## **Syracuse Gateway Apartments project roadmap**

<u>MaSPR-24-17</u>	<u>Staff Report – May 6, 2024</u>
<b>Application Type:</b>	Major Site Plan Review
<b>Project Address:</b>	To be known as 701-705 E. Fayette Street (proposed address) Includes: 701-03 E. Fayette St (parcel: 030.-16-18.0), 715 E. Fayette St (parcel: 030.-16-13.1), 706-08 E. Washington St (parcel: 030.-16-02.0), 712-16 E. Washington St. (parcel: 030.-16-03.0), 705 Fayette St (parcel: 030.-16-17.0), 709 Fayette St. (parcel: 030.-16-16.0).
<b>Summary of Proposed Action:</b>	Construction of a 7-story mixed-use residential building to be known as the Gateway Syracuse Apartments. The project will include demolishing three existing structures and adding 291 residential dwelling units along with 5,715 SF of retail/commercial space and additional amenity space for residents. 300 covered parking spaces are proposed inside the new apartment building in a parking structure on portions of the first and second floor. As part of the project, a subdivision (R-24-28) is concurrently proposed to combine the 6 existing lots into 1 single lot.

**RE: Site Plan Application  
Gateway Syracuse Apartments 701-705 E. Fayette Street  
CHA

Drawing No.:  
**C-101**  
Sheet 02 of 04

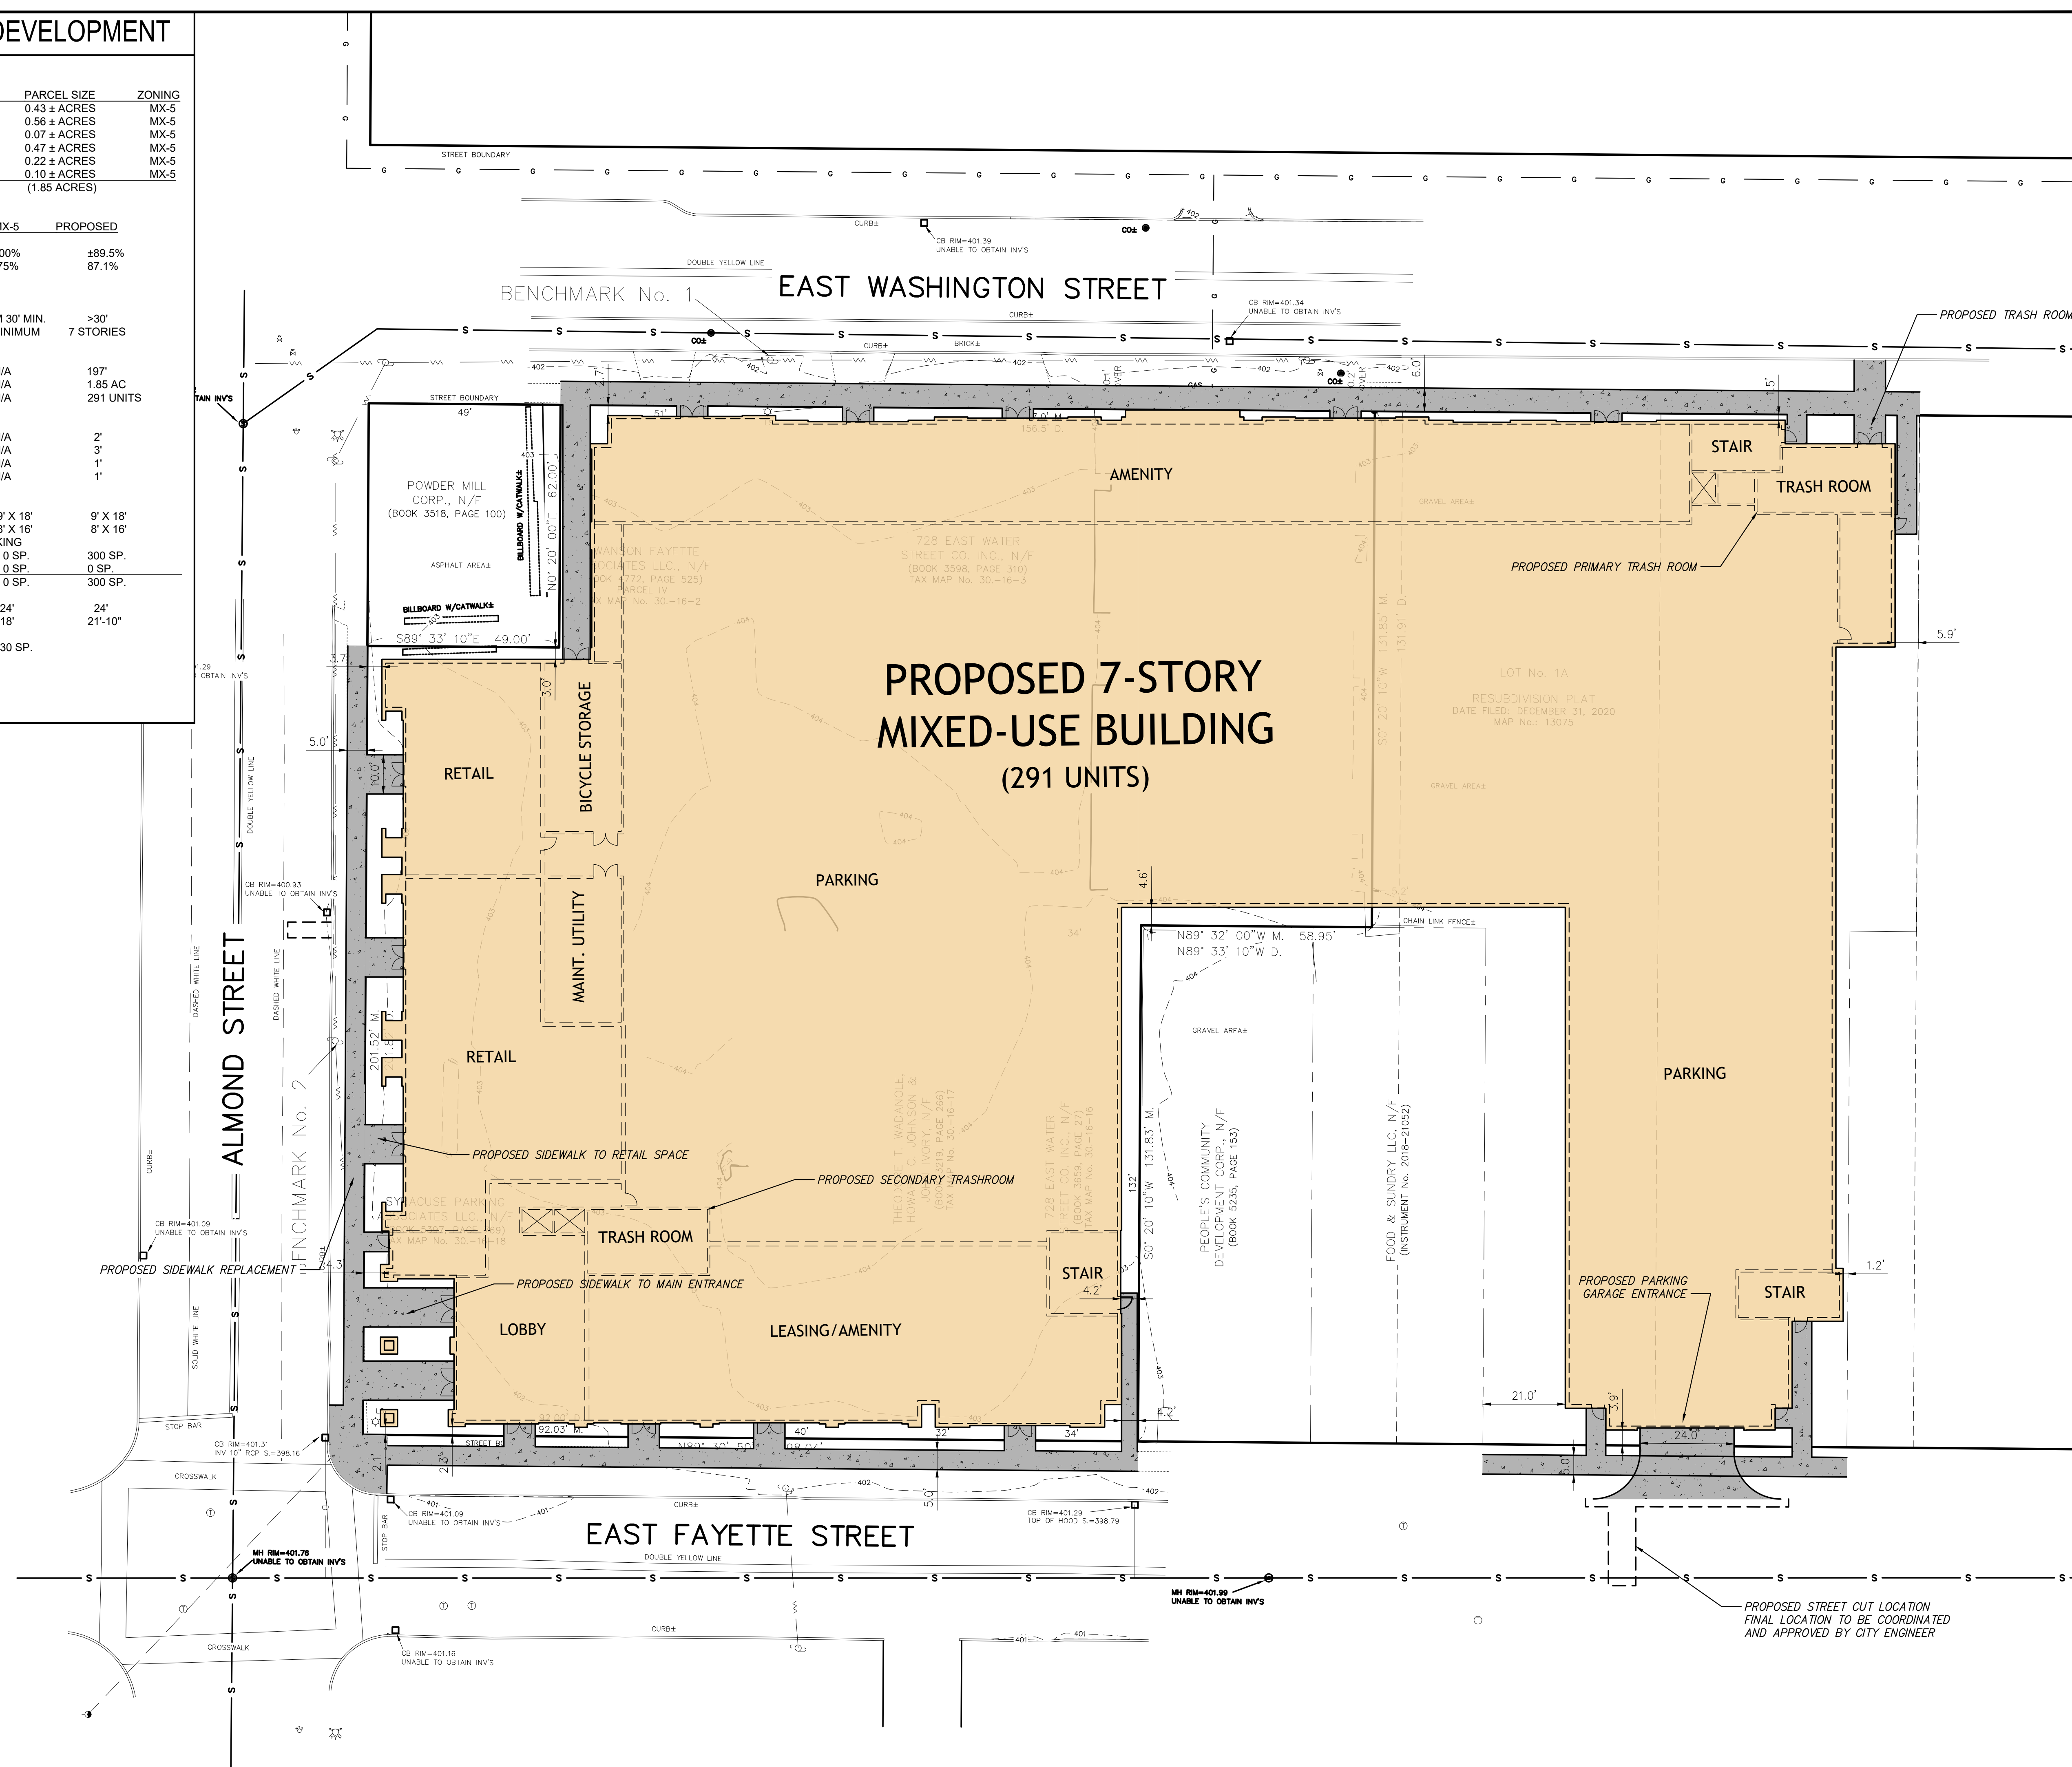
- 8) Updated site plan showing where trash pickup will be, where bike parking will be etc.  
***Response: Site plan now shows the trash pick up entrance and bike parking.***

Drawing No.:  
**C-301**  
 Sheet 03 of 04

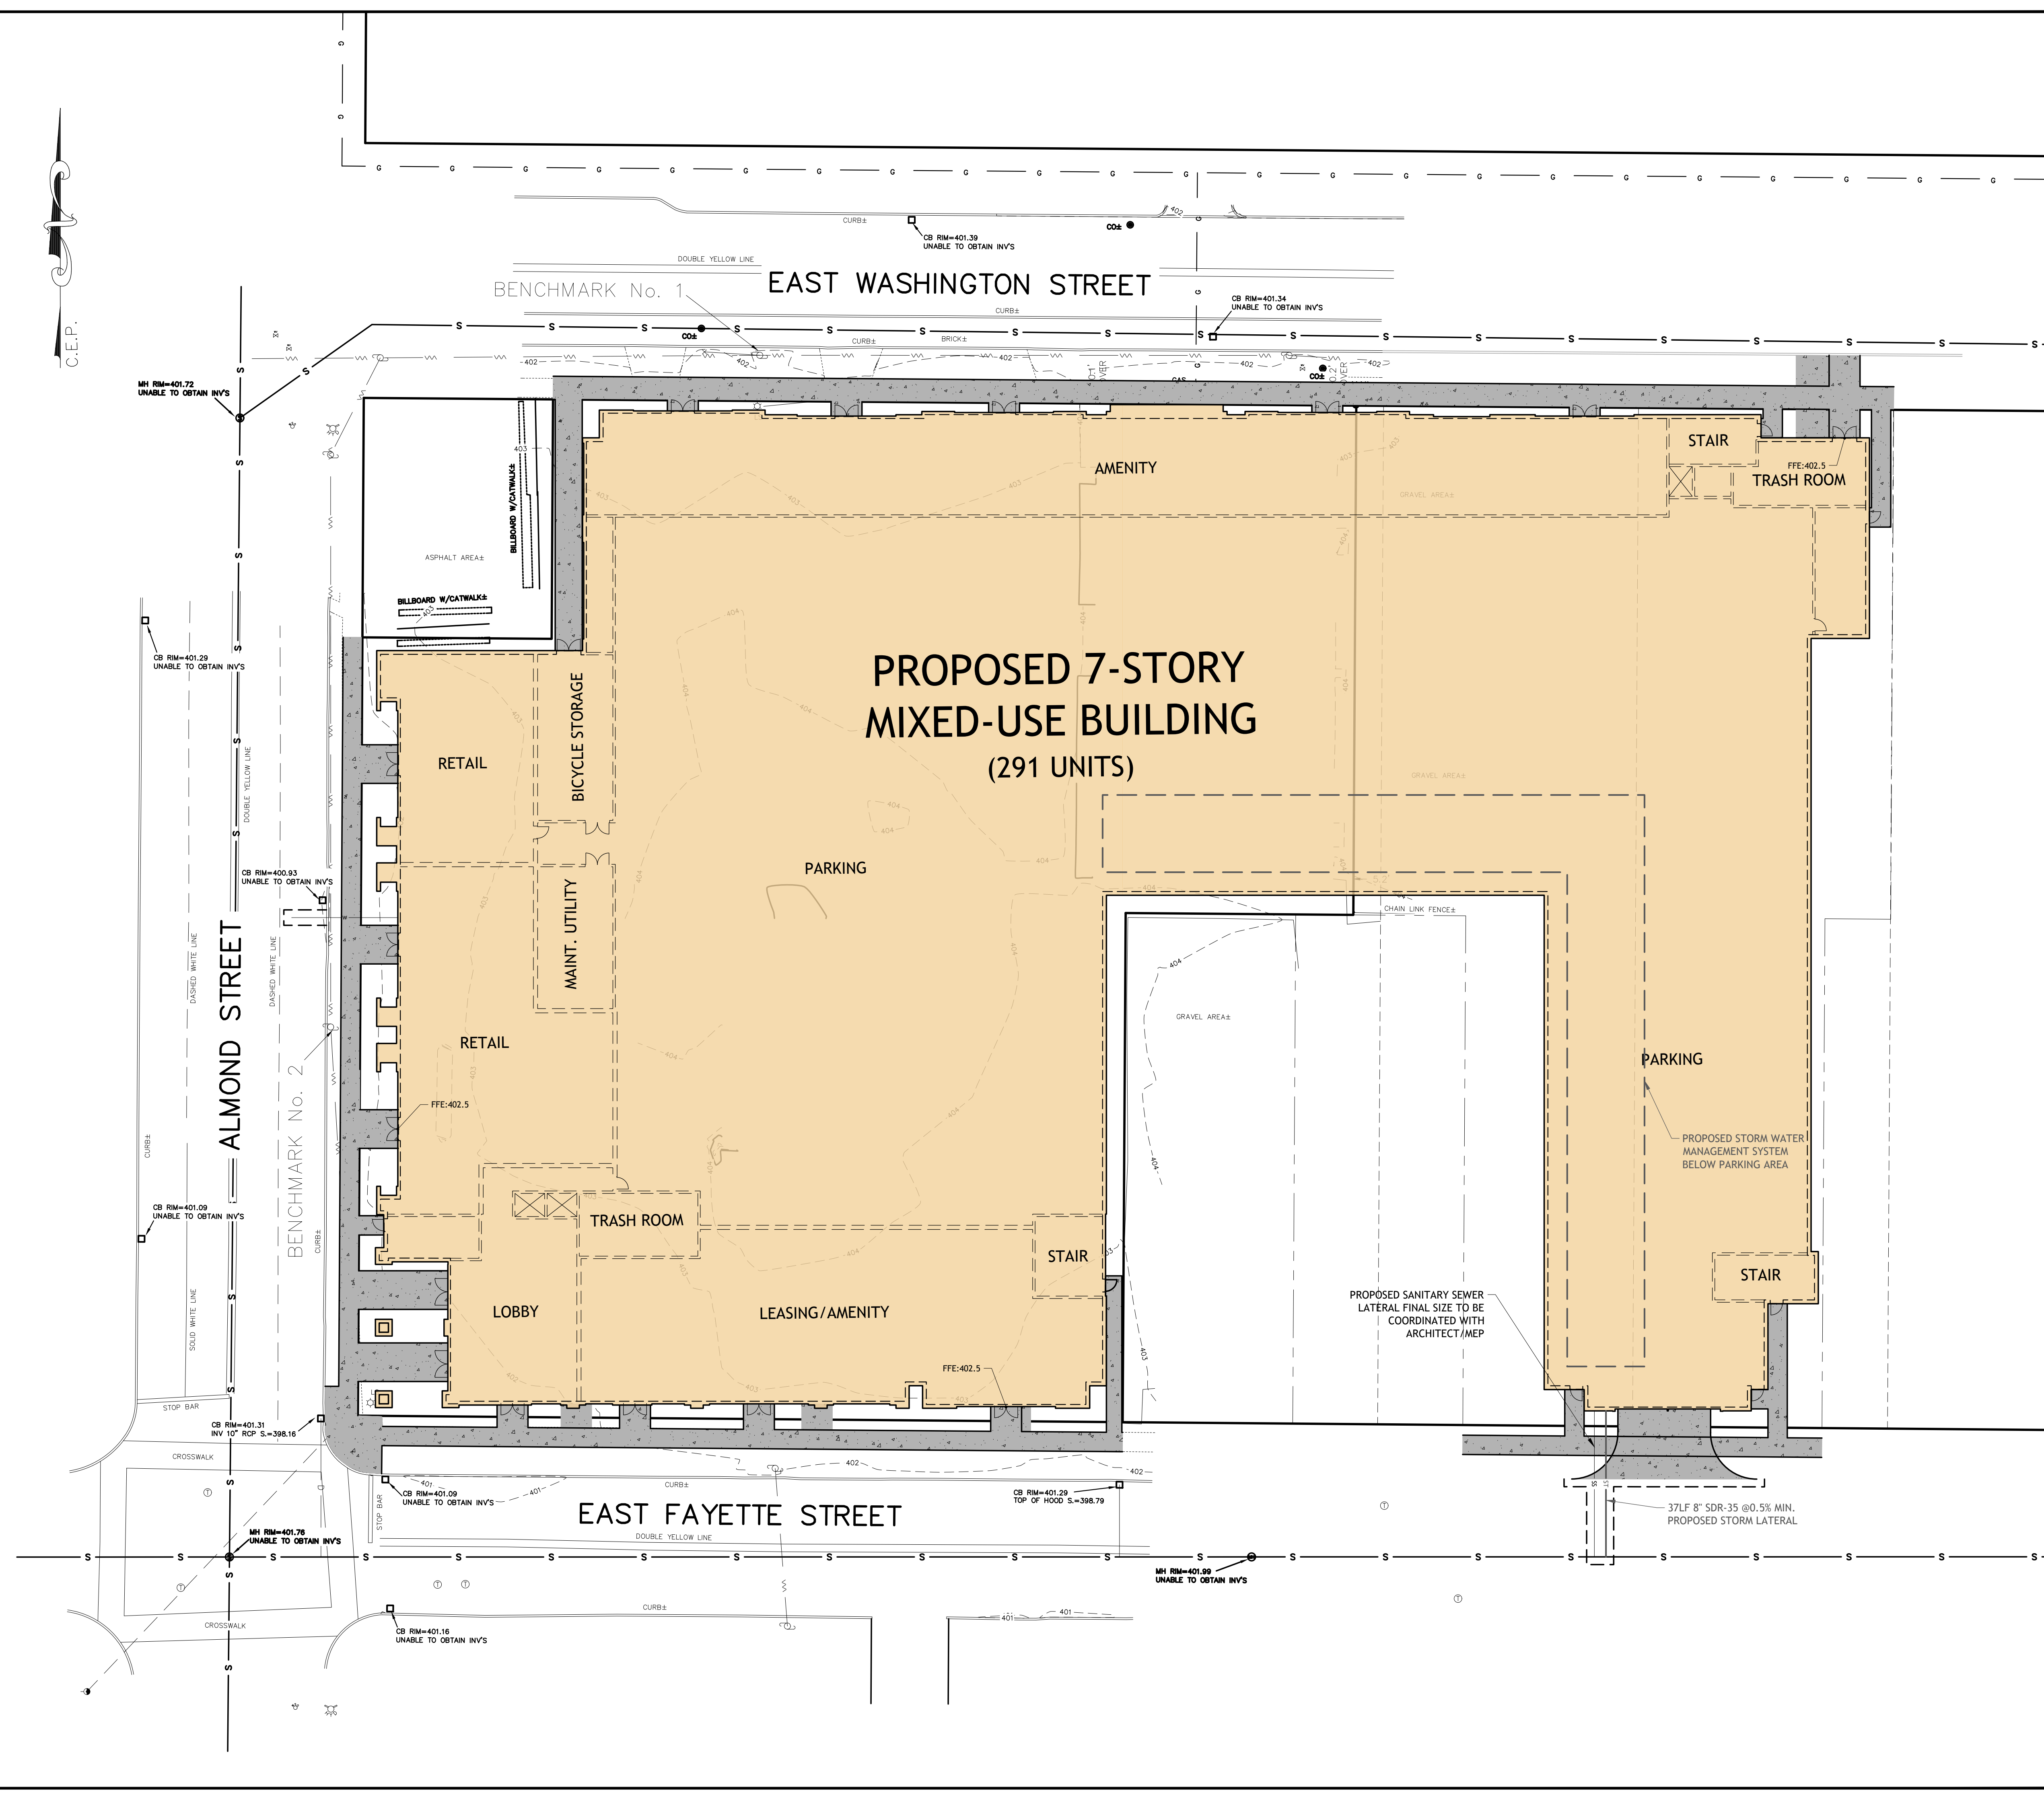
2. Impact on groundwater
  - a. All sub-questions are no, or small impacts, expect for question 4.e
    - i. Sub question 4e. Contamination next to water supply wells. Obviously, there will be no wells, but will there be any new water connections to main supply line that go through areas of contamination? No plans show where utility connections will be.

- 10) Sanitary sewer and public water hookup information  
***Response: Approximate sewer and public water connection locations are now shown on the plans, please see C-301 Utility Plan. Final sizing and locations will be coordinated with the City DPW, City Engineer and NYSDOT to limit disruption to traffic flows for connections and future maintenance.***

***Response: The location of the water connection is now shown on the site utility plan and will not impact the ground water the water main piping is water tight and will be wrapped in 8 MIL Polyethylene to prevent corrosion of the service.***
